Environmental Monitoring Works for Contract No. ED/2018/01 – Kai Tak Development – Stage 4 infrastructure at the Former Runway and South Apron

Submission of Landscape Mitigation Plan (Revision 2)

SUBMISSION REVIEW FORM

Landscape Mitigation Plan

Section A (Road D3 - Elevated Landscaped Deck)

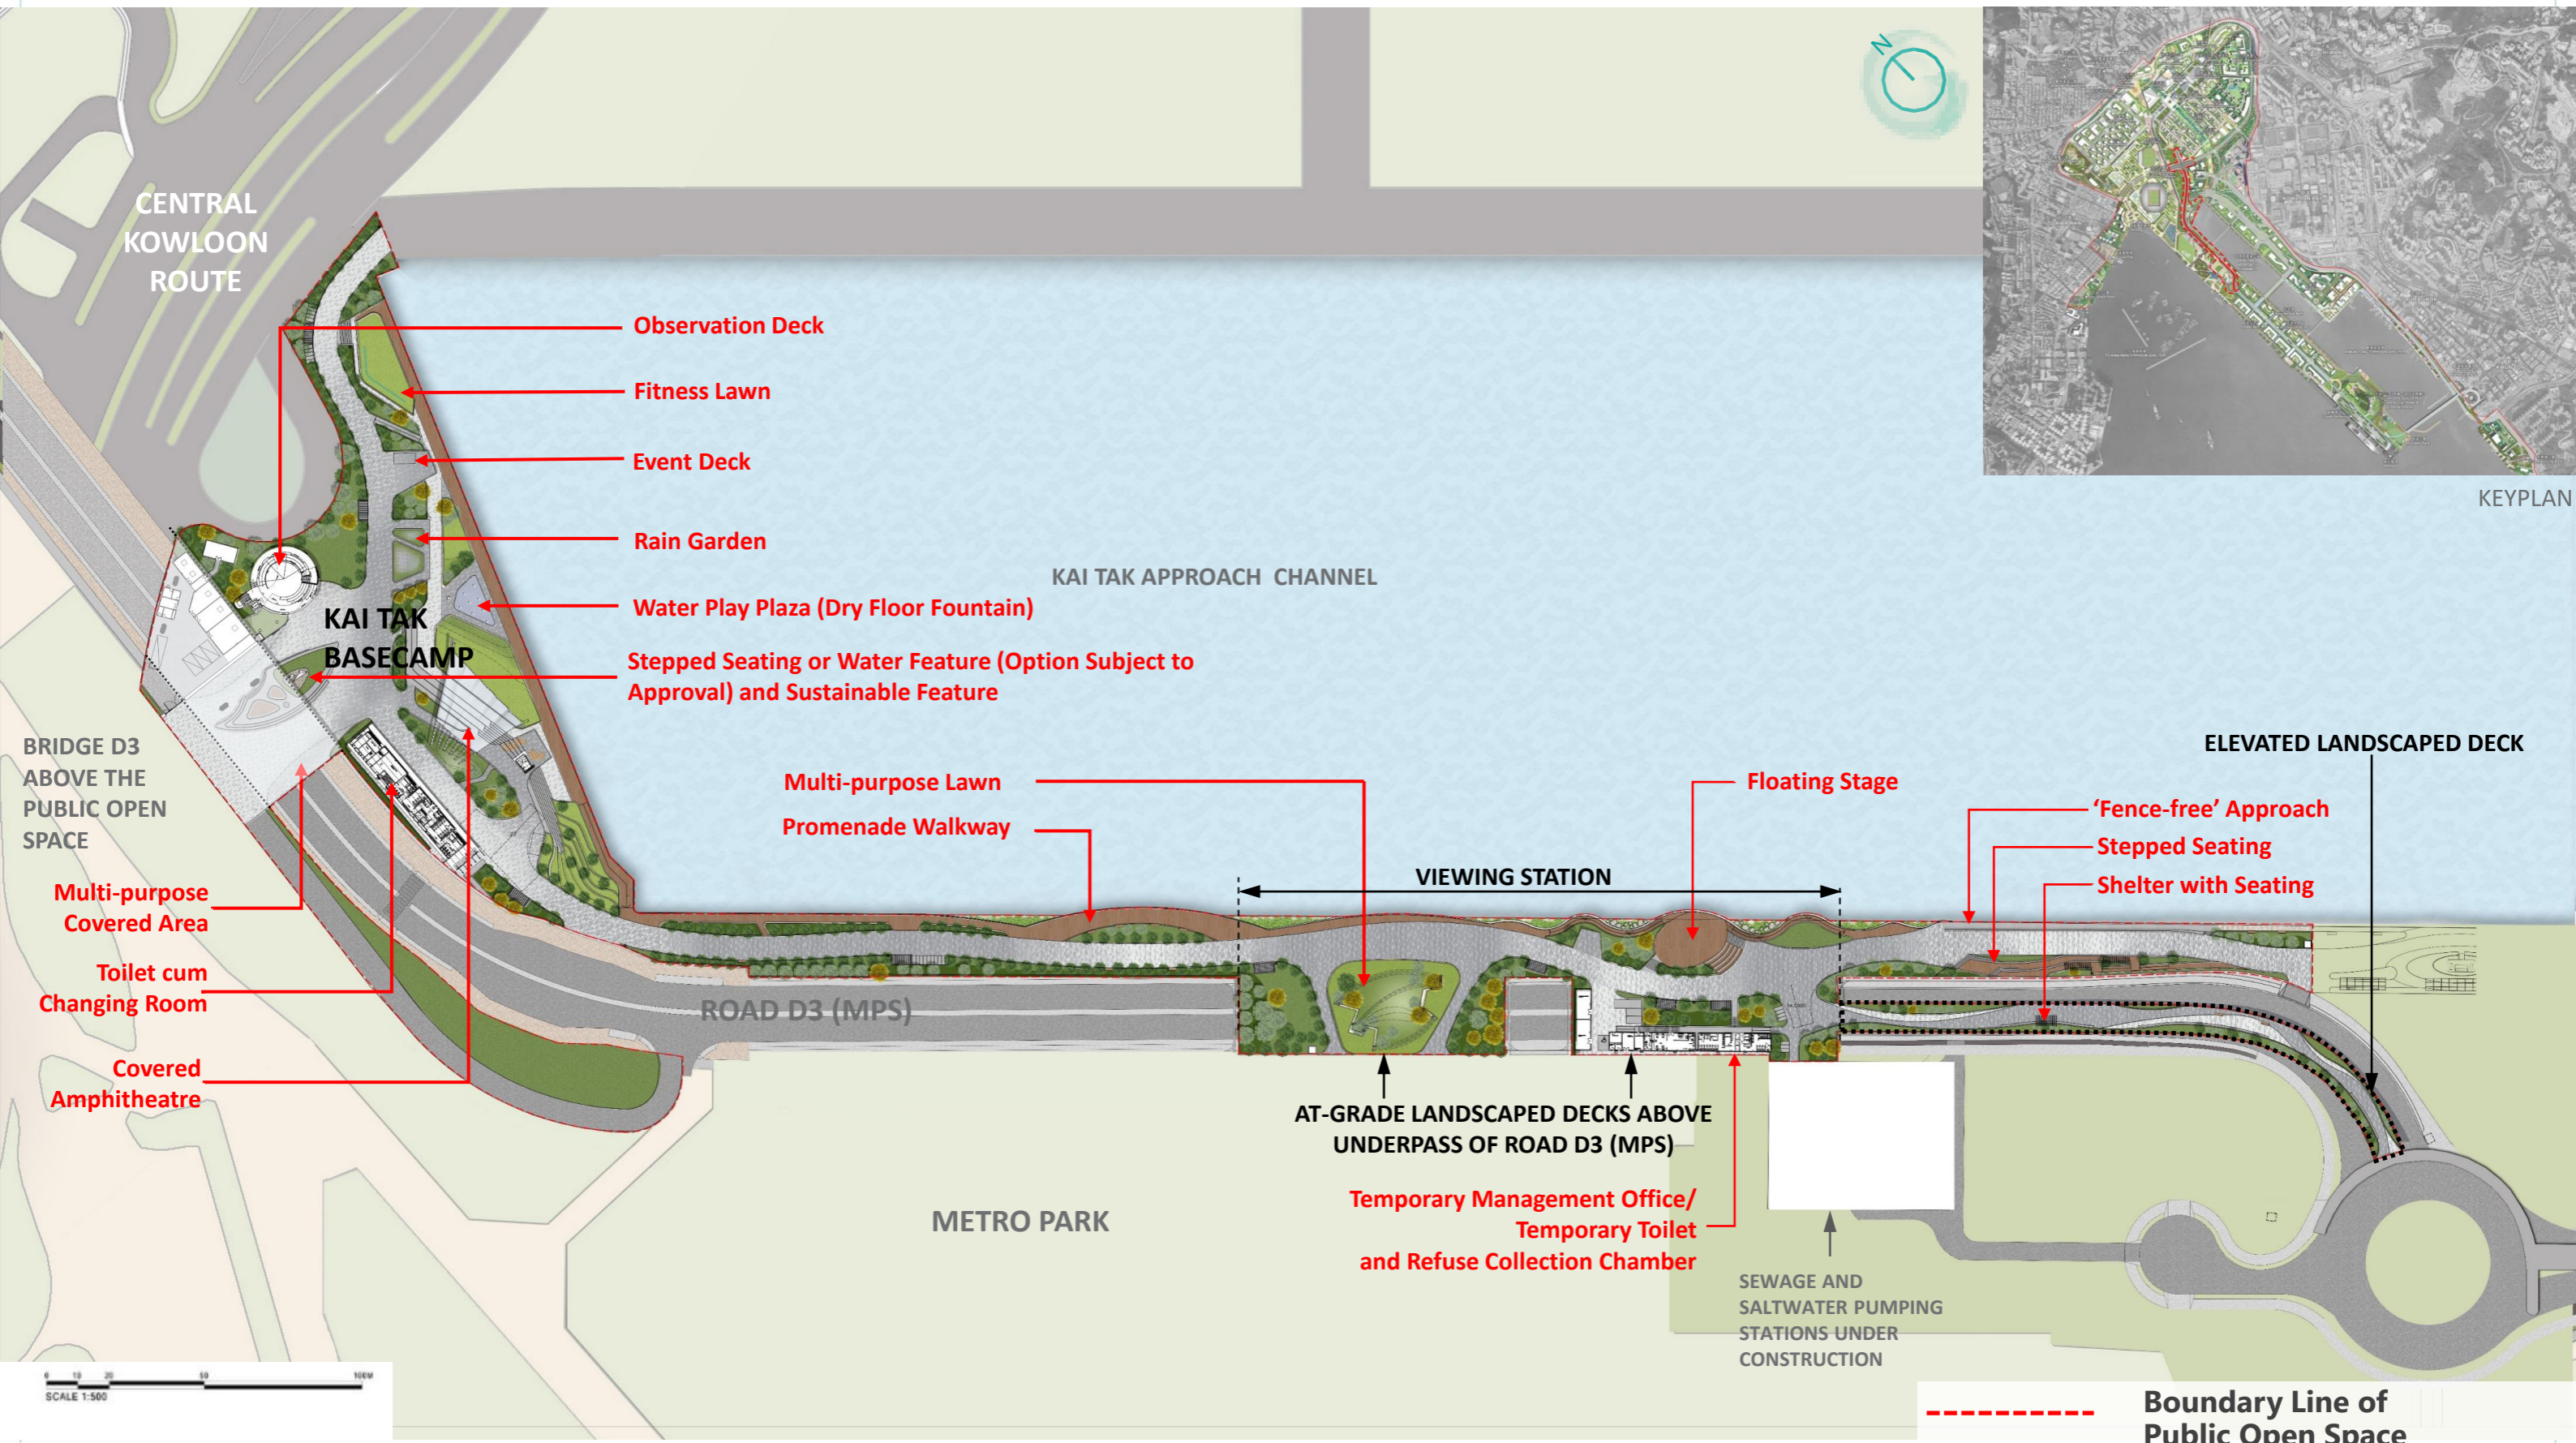
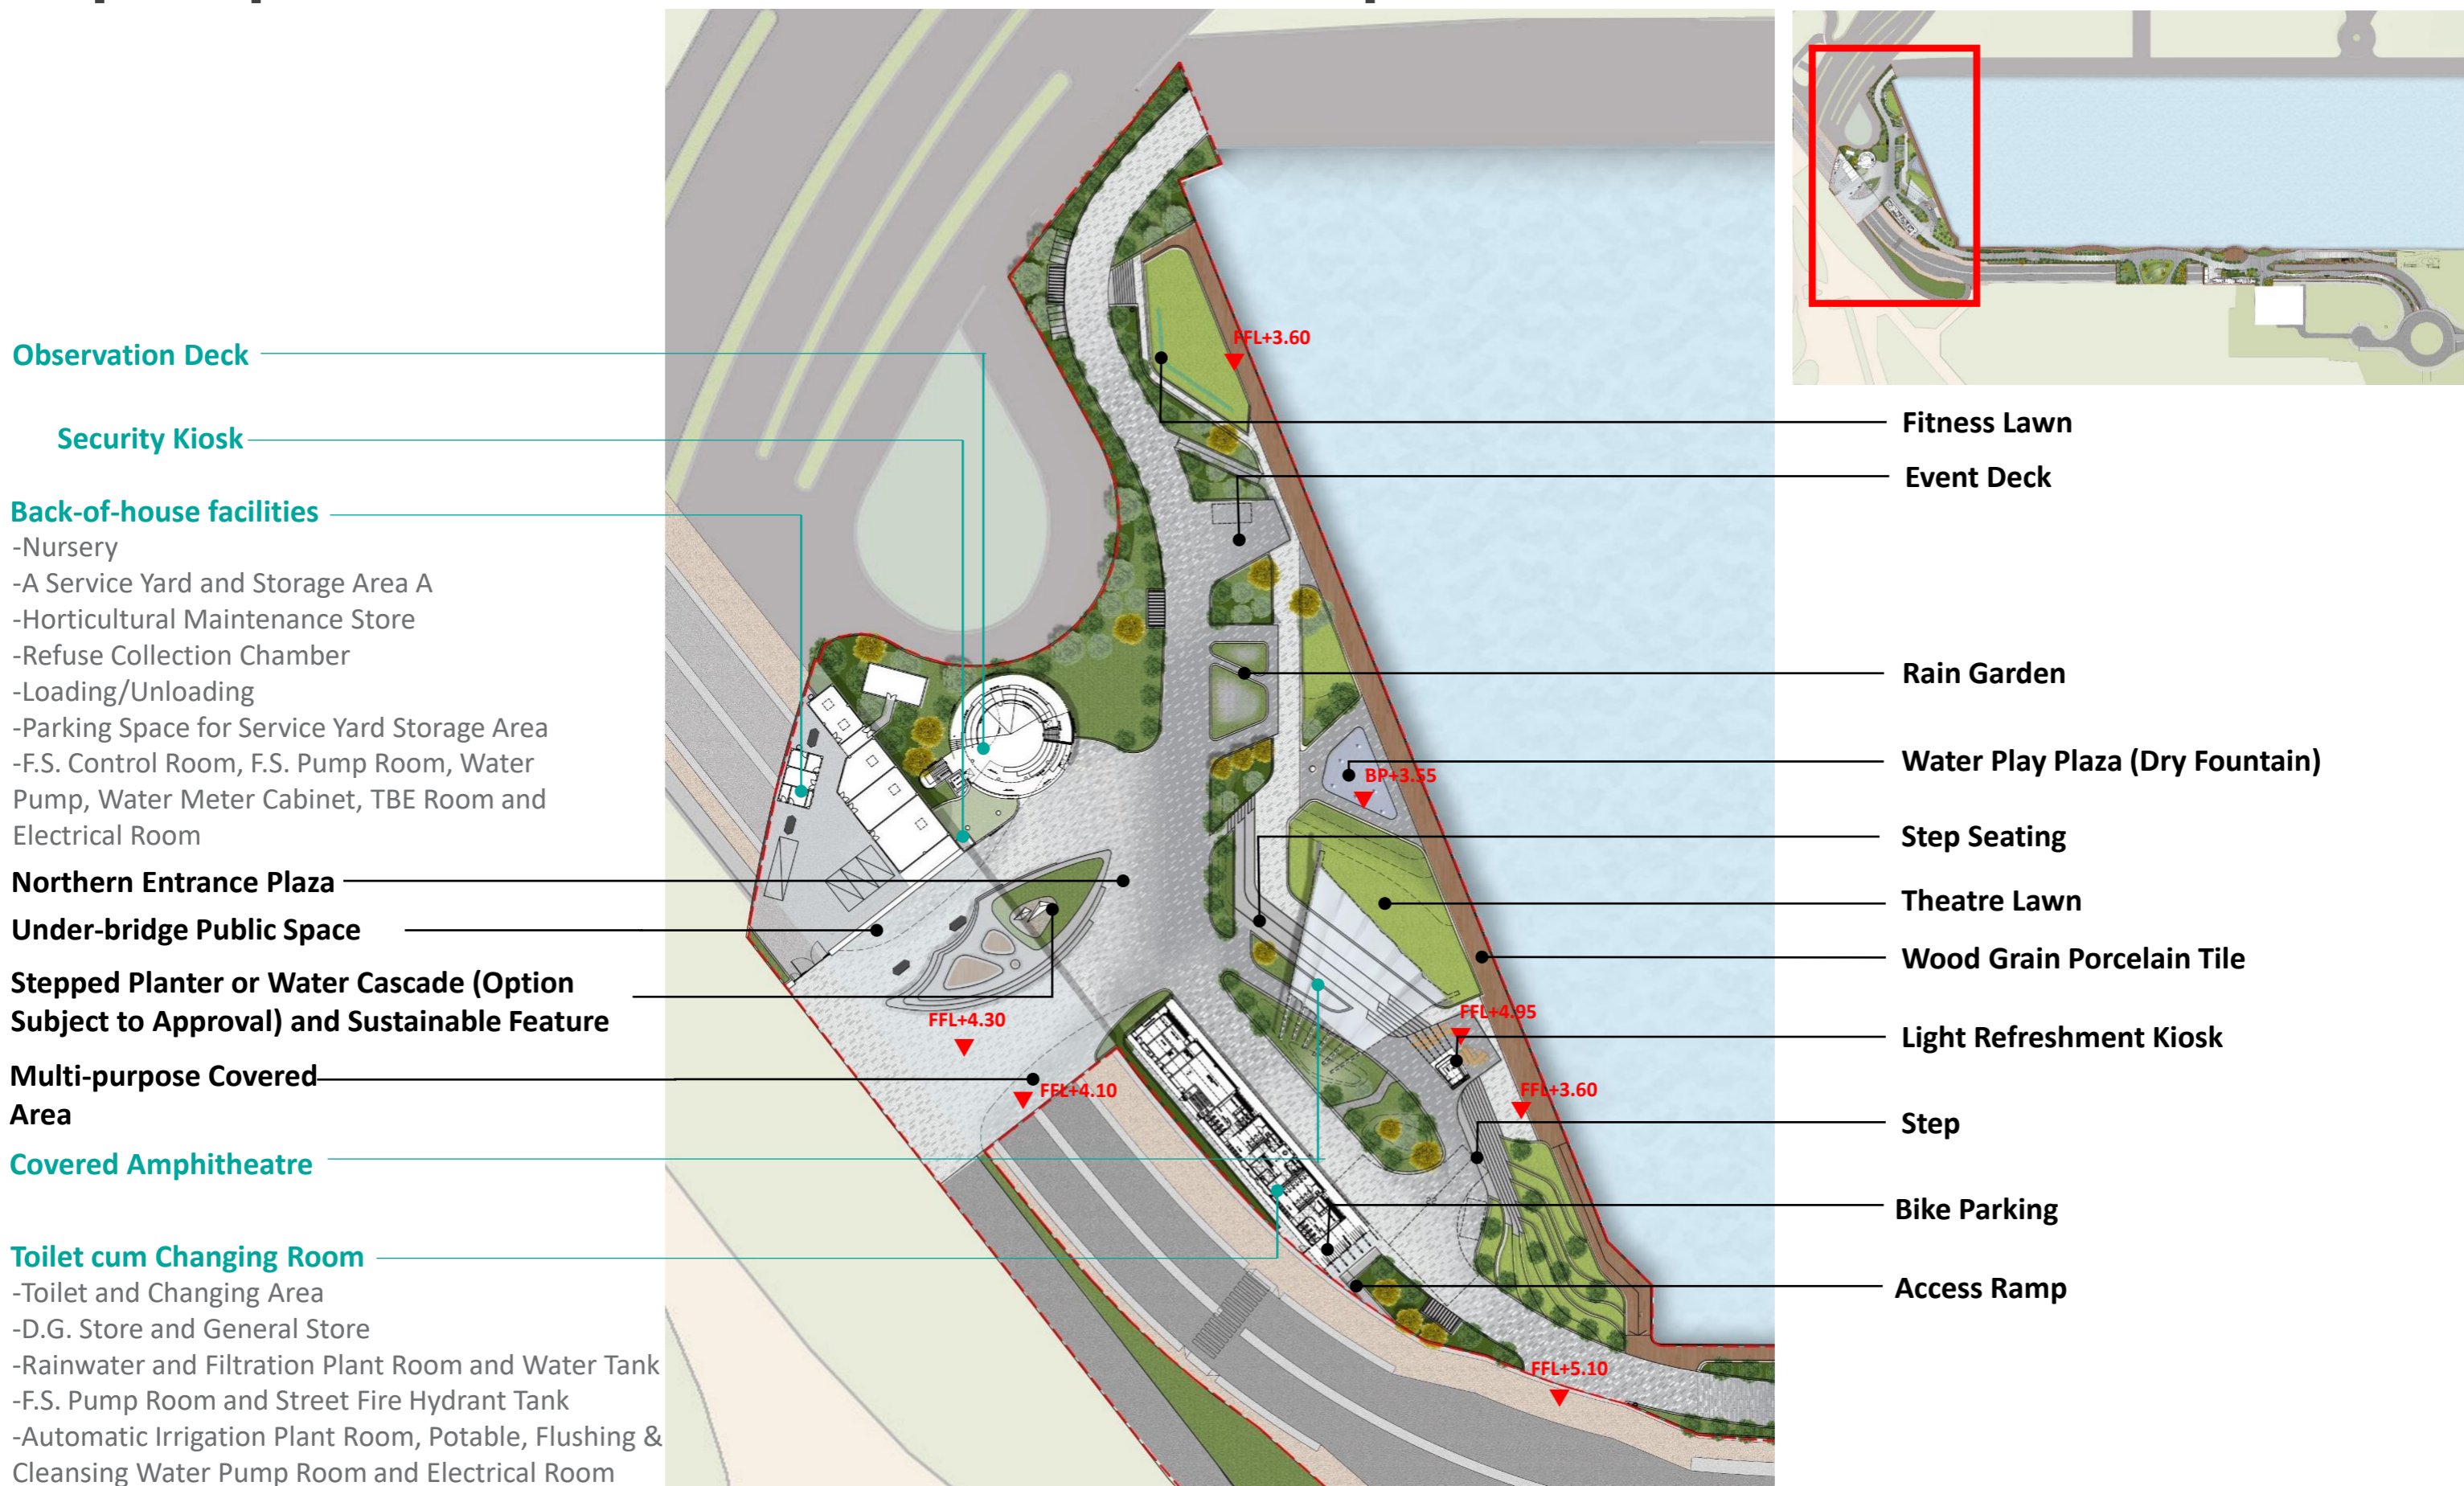
ITEM NO.	REVIEWER	DOCUMENT REFERENCE	REVIEWER'S COMMENT	OUR RESPONSE
				provided in Figure 57 for reference.
10.	EPD	<u>Visual Impact</u>	Paragraph 2.2.9, Figures 20 & 55 - The trellis seating at the elevated landscaped deck as stated in Line 7 is not shown in Figures 20 and 55.	Noted. The trellis seating at the elevated landscaped deck is shown in Figures 20 and 55 in this submission.
11.	EPD	<u>Visual Impact</u>	Figure 11 - Please consider annotating the observation deck in Figure 22.	Noted. 'Observation Deck' has been annotated in Figure 11.

Section A (Road D3 – Elevated Landscaped Deck)

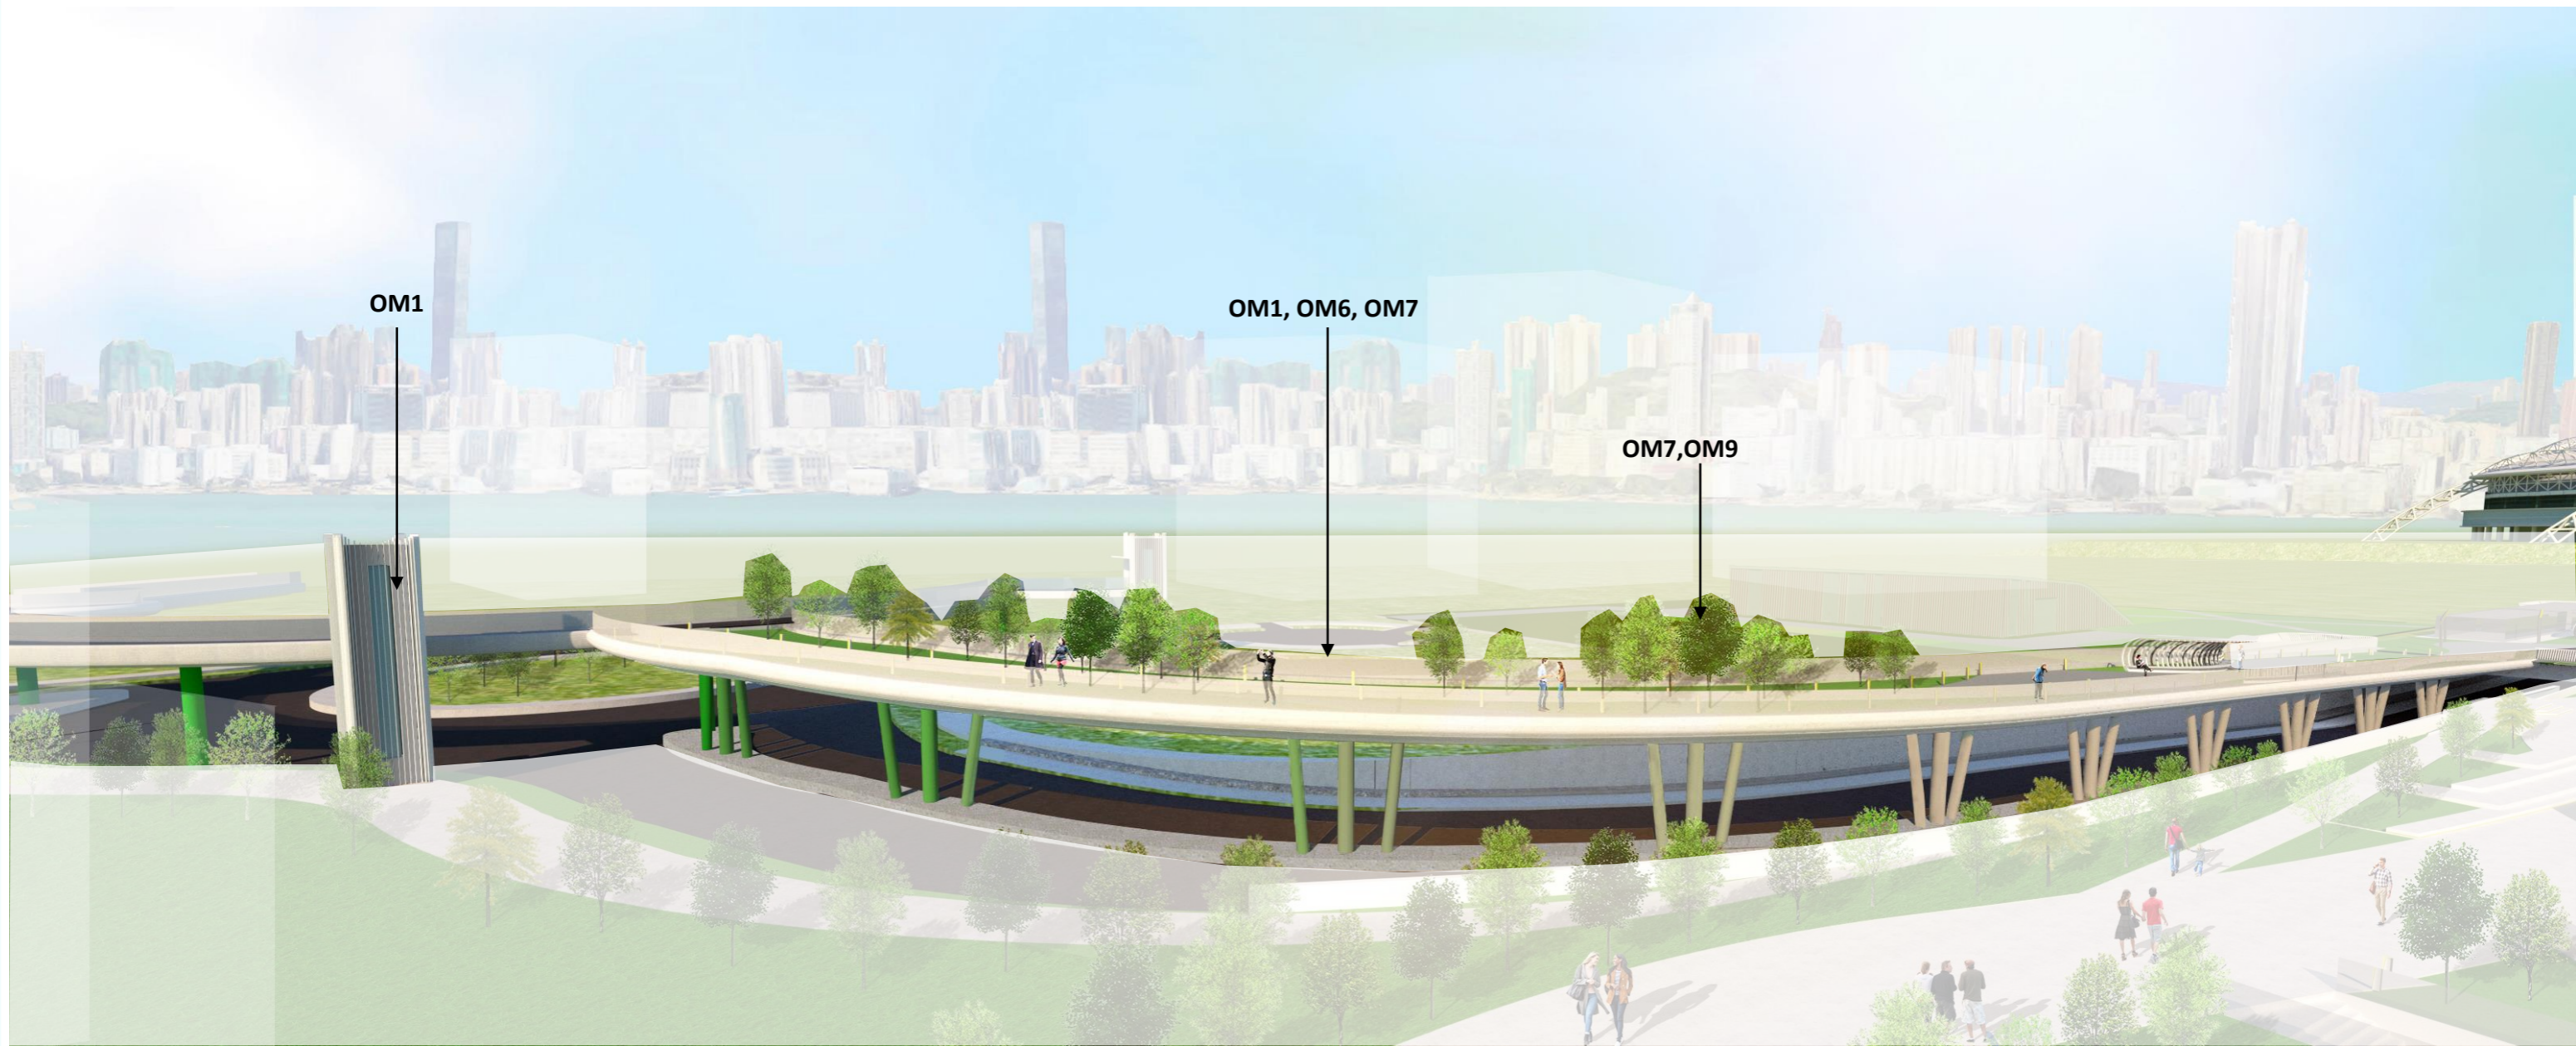
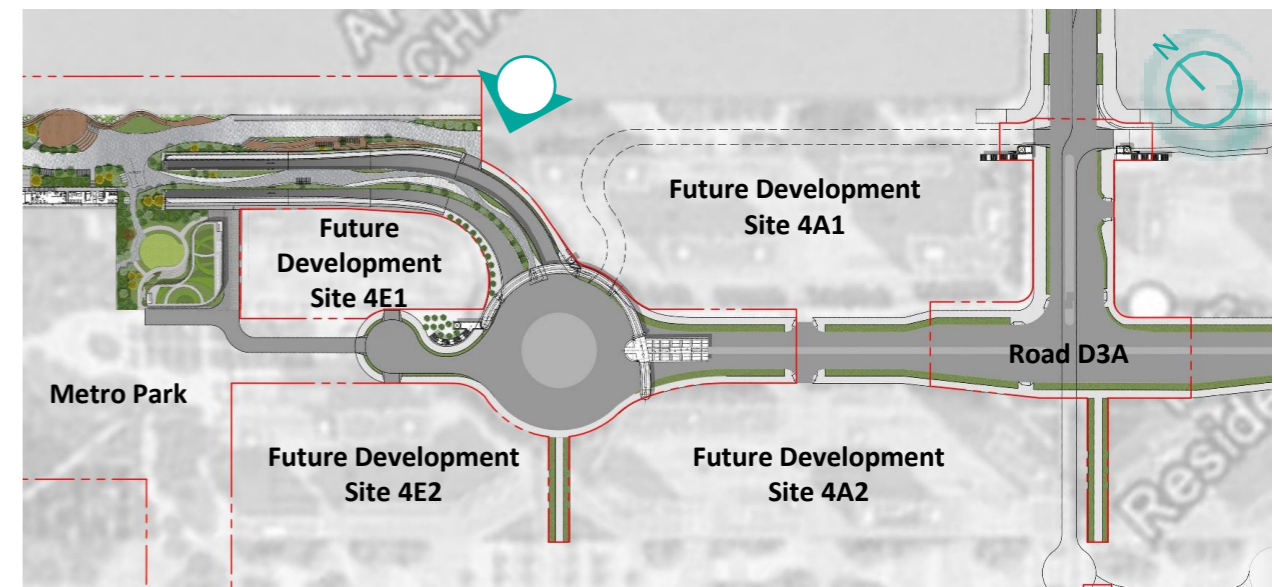
7.	EPD	<u>Visual Impact</u>	Table 4: OM6 - It is unclear that how the minimum soil depth and height could avoid excessive bulk of the elevated landscape deck. Please elaborate.	Noted. The description has been elaborated in this submission where the elevated landscaped deck is proposed with a tapered profile to create a thin edge and avoided excessive bulk of the elevated landscape deck. Tree planting is proposed at the inner portion with 1.2m soil depth while shrubs/groundcover planting is proposed at the remaining outer portion with less soil depth as shown in Figure 55's section.
